ChiCycle Oppose the Inappropriate Conversion of Westgate Pavements into Shared Use Cycle Tracks

The consultation period for [Traffic Regulation Order \(TRO\) CHS9038RC](#) closes on the 5th August 2021.

ChiCycle advise that this TRO contains some welcome changes (New Zebra Crossings) that should be encouraged; Other elements in this order might become worthwhile infrastructure with improved design (e.g. a Dutch Style Roundabout); However, we believe the creation of sub standard shared cycle tracks around the Sherborne-Rd/Westgate junction (TRO items iii & iv) should be strongly opposed for the following reasons:

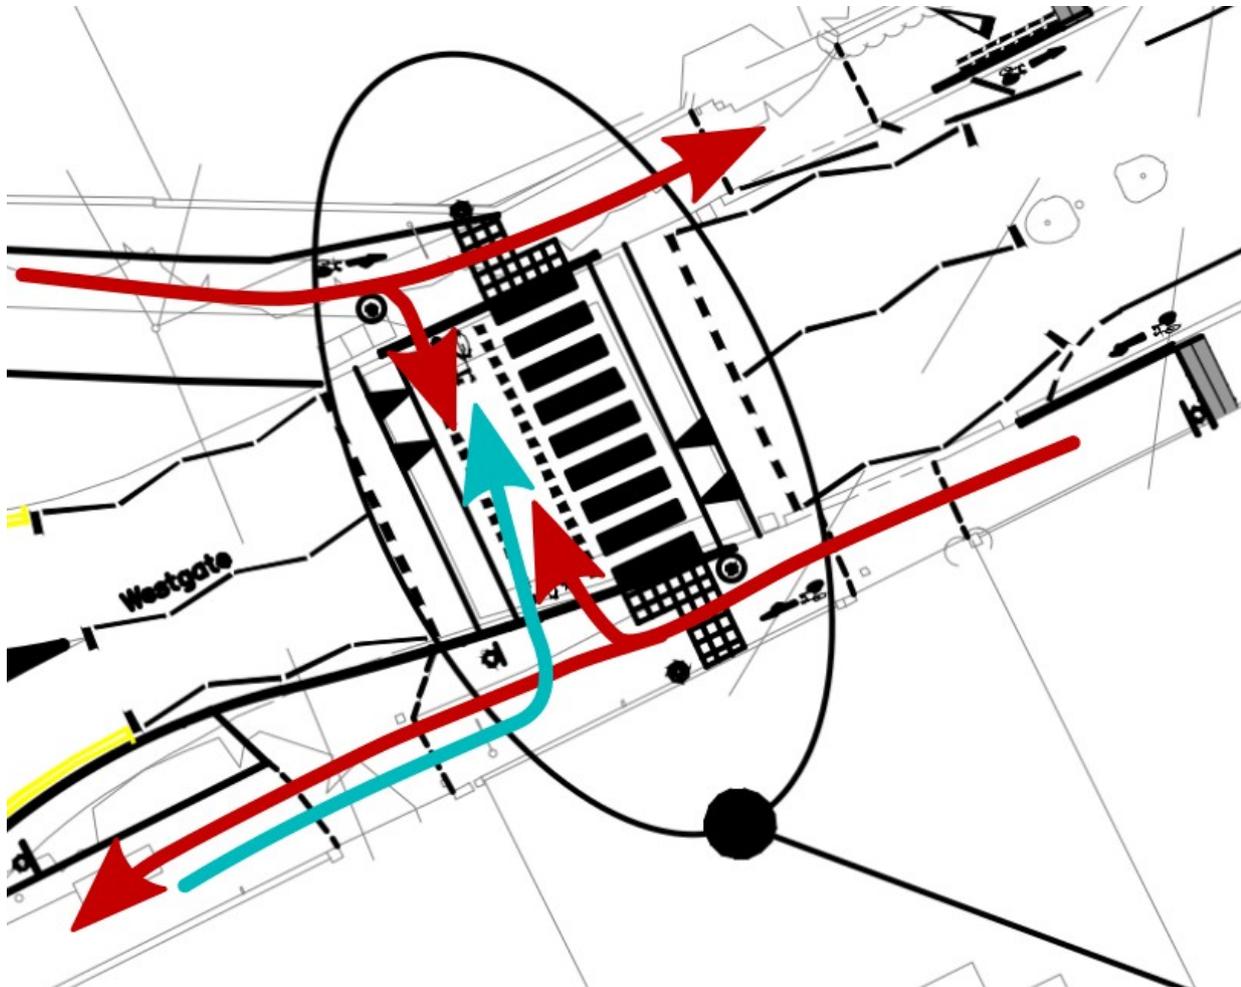
Similar issues are present in the proposed design for a parallel crossing across Westgate. Because the proposed cycle tracks on Westgate pavements are significantly below minimum DfT widths for shared use, it will be even harder for drivers to predict if cyclists are about to turn to ride over the crossing, or if they will continue to ride along the pavement. The image below highlights the many potentially confusing manoeuvres cyclists could make at the proposed Westgate parallel crossing.

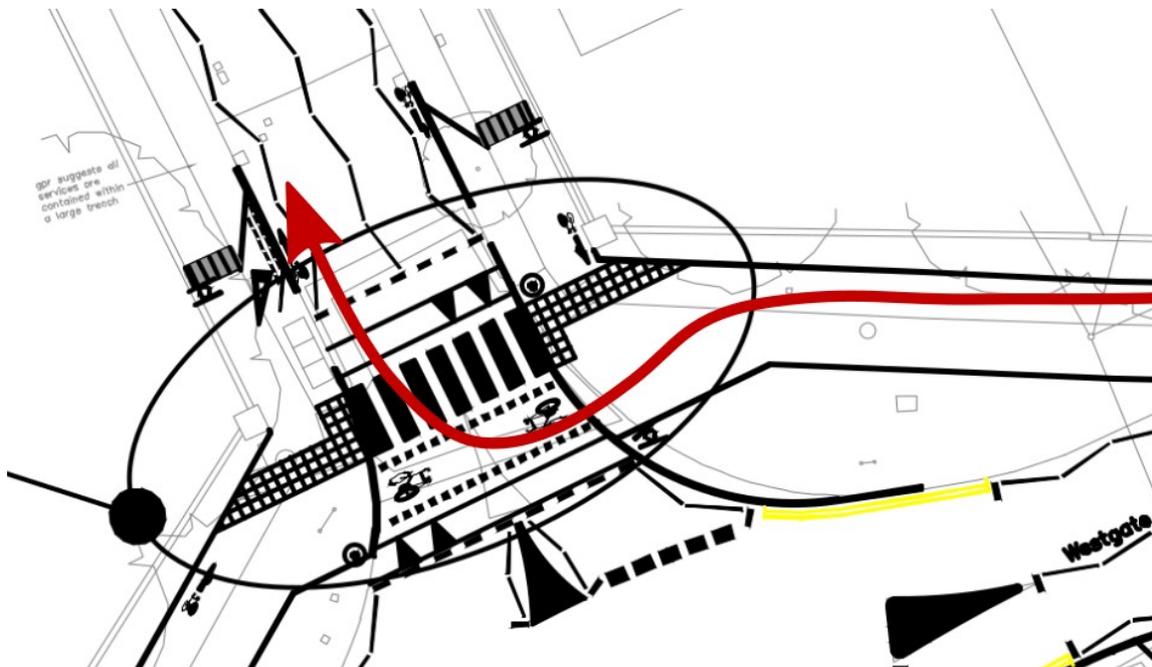
The issue with cyclists regularly wishing to turn right at the Westgate crossing is illustrated in the following diagram:

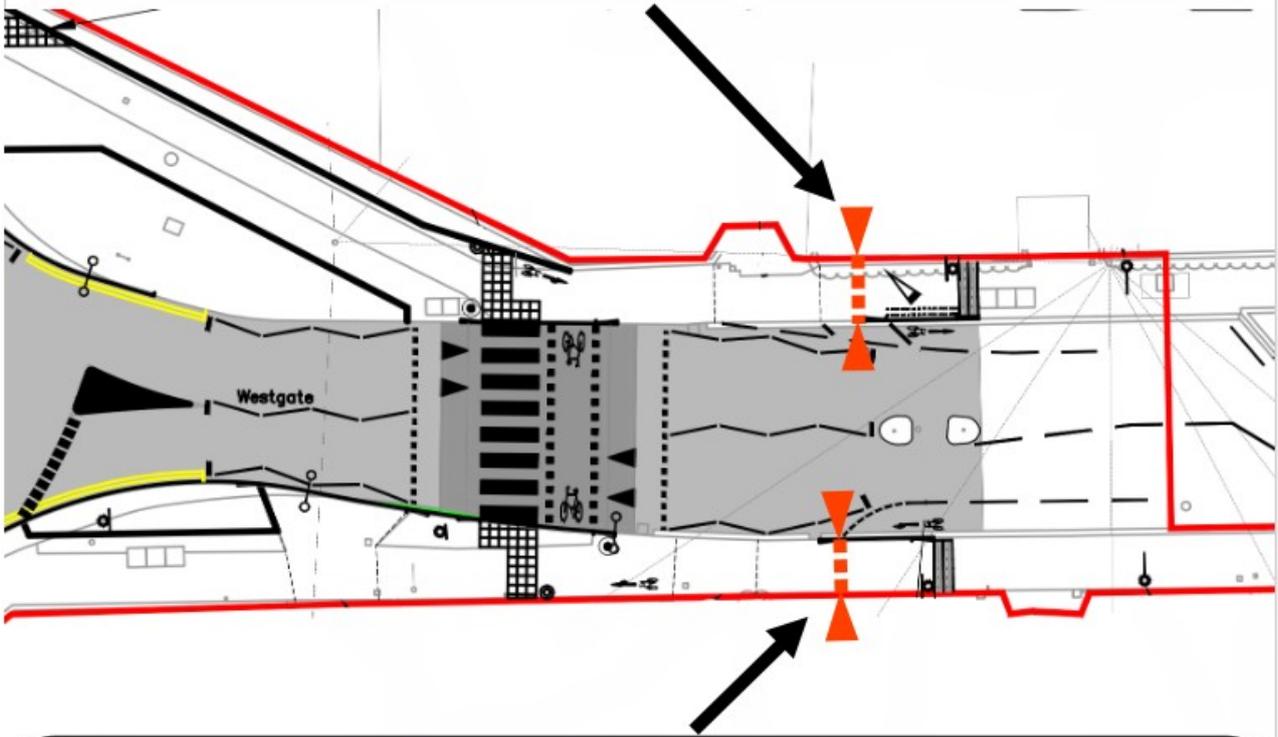
On the south of Westgate, the proposed path width is only 2.8 metres

However, LTN01/20 recommends a 3.7 metre width shared track at this location to comply with current guideline widths.

The proposed width of this shared use cycle track is only **75%** of the minimum width recommended by DfT!

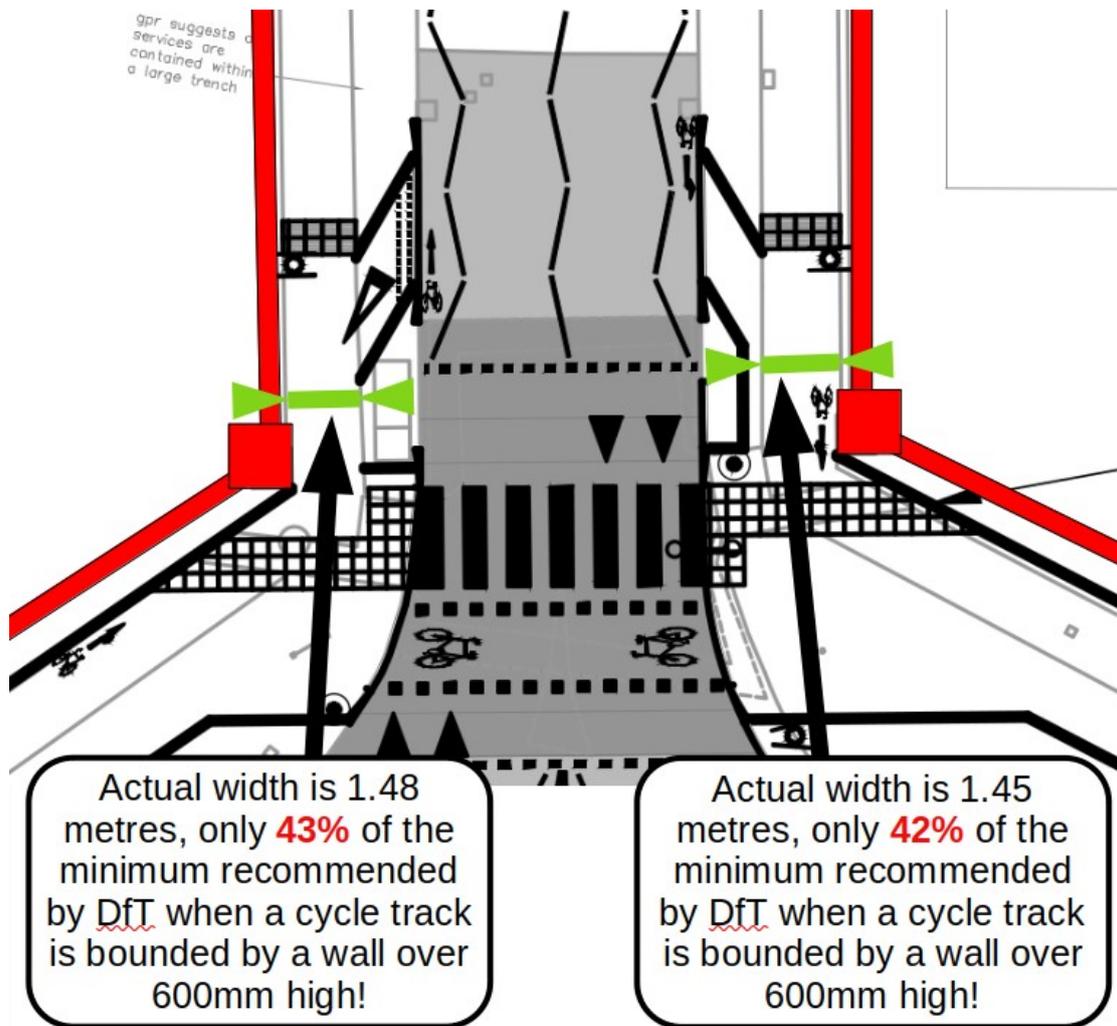
On Westgate north side, the proposed path width is 1.9 metres adjacent to the beech hedge.

LTN01/20 requires a 3.7 metre width track at this location to comply with its guidance.

The proposed width of this shared use cycle track is only **51%** of the minimum width recommended by DfT!

On Westgate south side, the proposed path width is 2.3 metres.

As above, LTN01/20 recommends a minimum 3.7 metre width shared track at this location to comply with current guideline widths.

The proposed width of this shared use cycle track is only **62%** of the minimum width recommended by DfT!

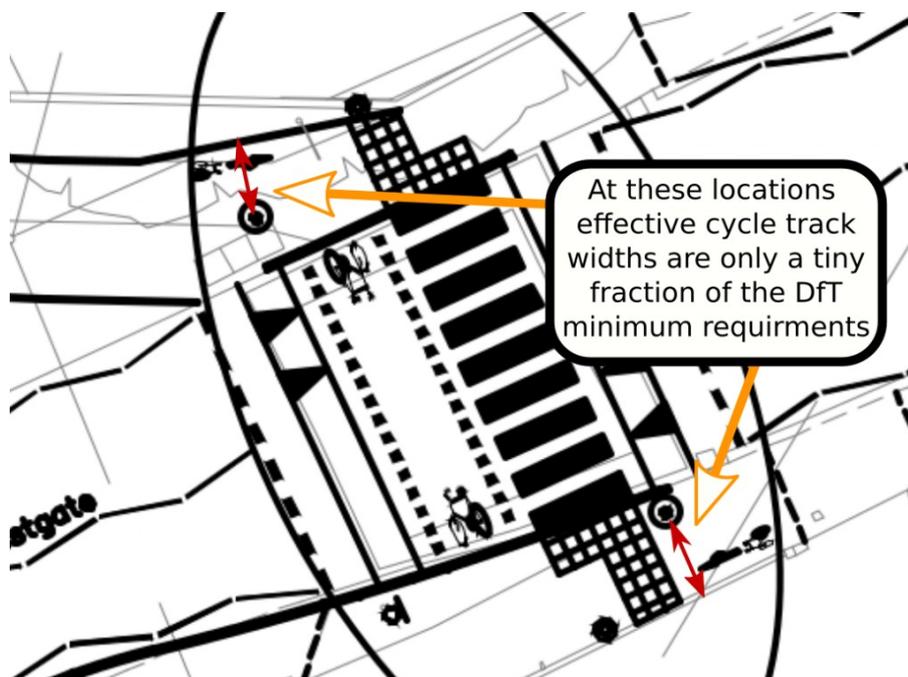
In positions where yellow globes are proposed at each end of the Westgate parallel crossing, significant difficulty will arise if these are mounted onto vertical posts rising up from the pavement. The effective width at this section of the shared use cycle track would then only remain a tiny fraction of the DfT minimum for shared use facilities. This is illustrated in the diagram below.

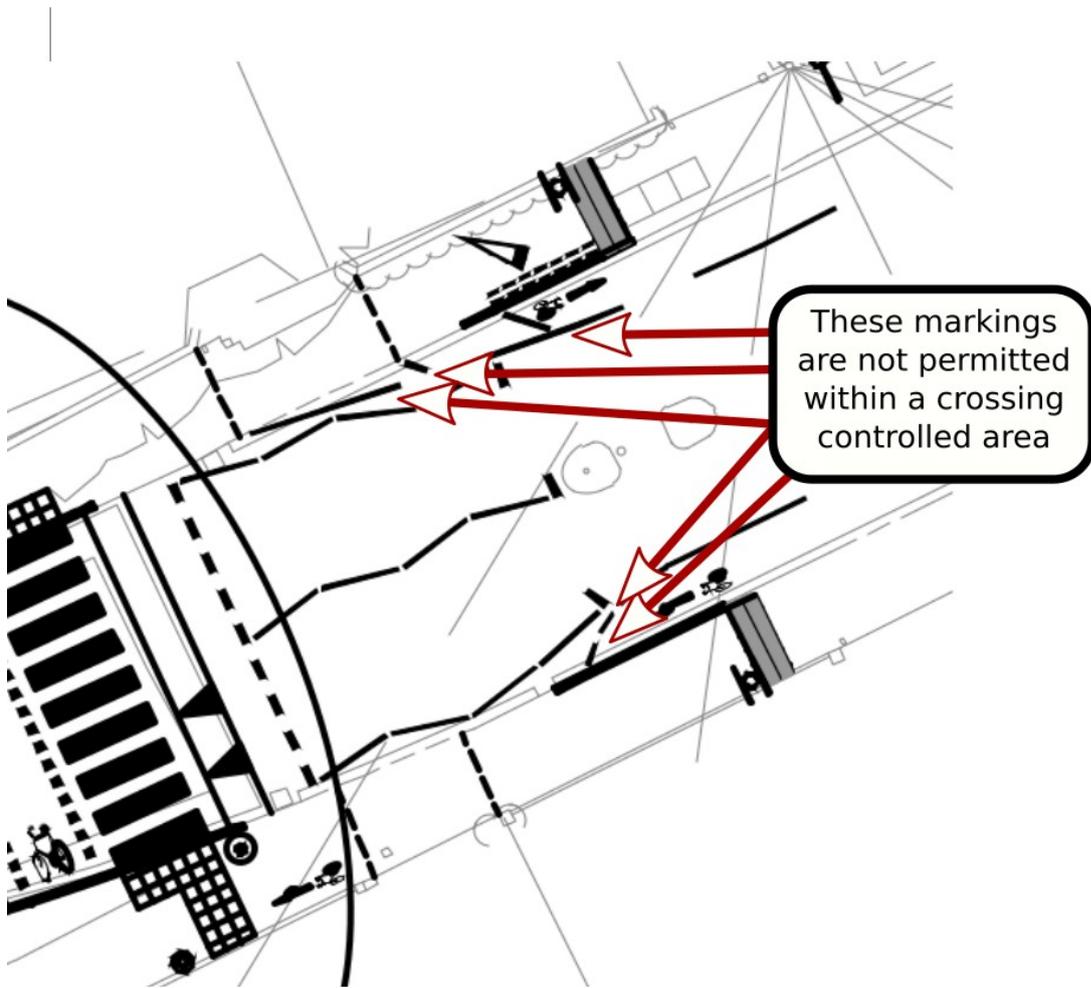
Road marking issues are evident within the proposed Westgate parallel crossing control area. This is illustrated in the diagram below.

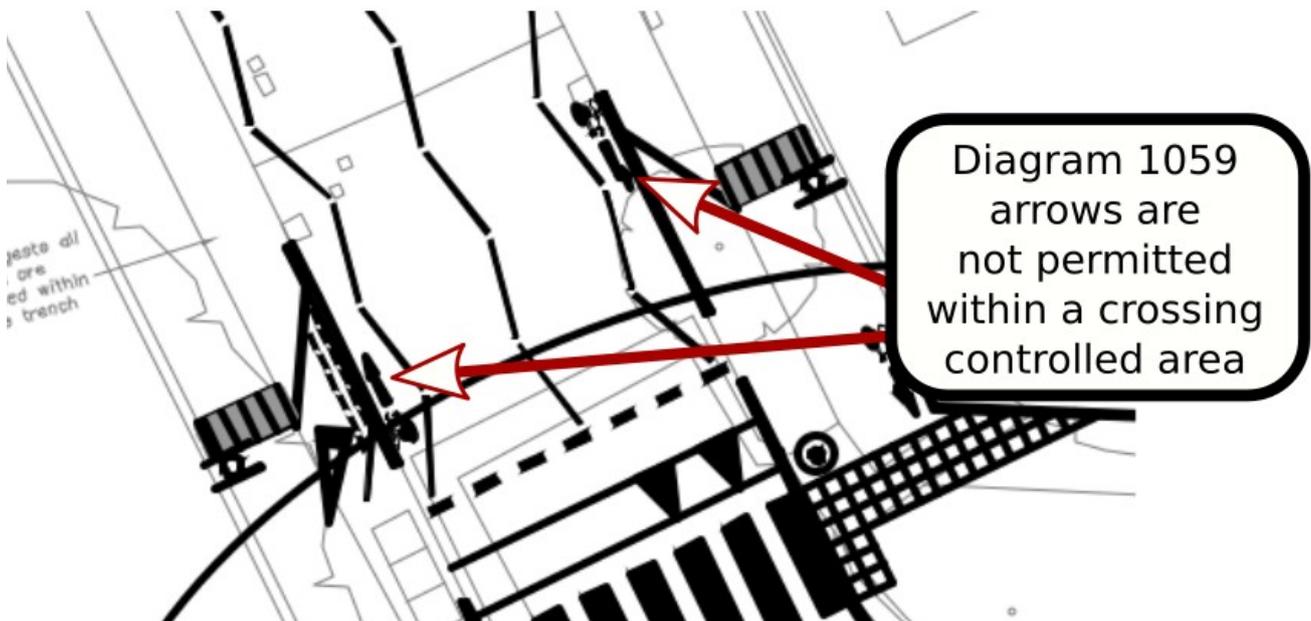
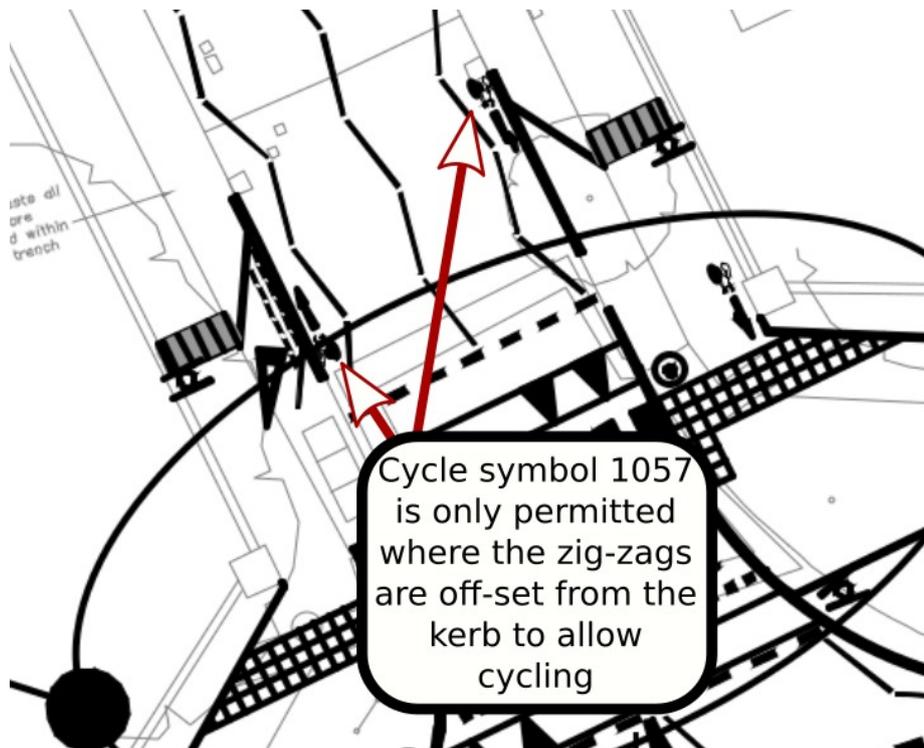
Road marking issues are also evident within the proposed Sherborne Rd parallel crossing control area. This is illustrated in the following diagrams.

If diagram 1057 symbols are to mark out a cycle lane running between the zig zag lines and the carriageway kerb, the absolute minimum width for the cycle lane width at any constraints is 1.5 metres. This requirement is given in LTN1/20 in table Table 5-2: Cycle lane and track widths.
